August 11, 2020

TO: Village of Pittsford Board of Trustees
FROM: Village of Pittsford Planning Board

Comments and Suggested Changes to the 2019 Active Transportation Plan

Inlet flush in the curb face.

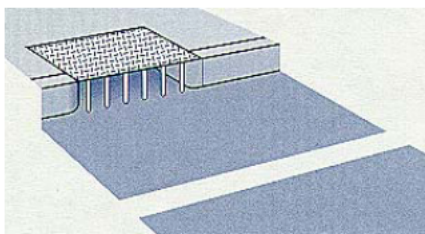
p. 87: Change drains in the road to in-curb drains to make more usable room on the sides of roads.
